Access Compliance Report

Public Rights-of-Way

(Curb Ramps)

Intersection ID: 10825	Main Street: E_26TH_ST	Cross Street: N_DAVIDSON_ST	Location: W
ADA ID: 6E5173A87C7F	Ramp Type: Directional1	Initial Pass/Fail: Fail	Overall Compliance: No
		Severity Score: 10

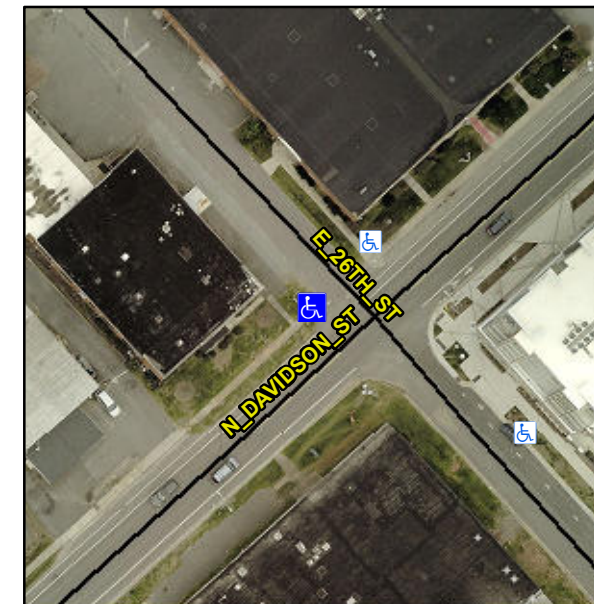
NO CURB

R304.5.1, R304.5.3

Remove & Replace Entire Ramp.
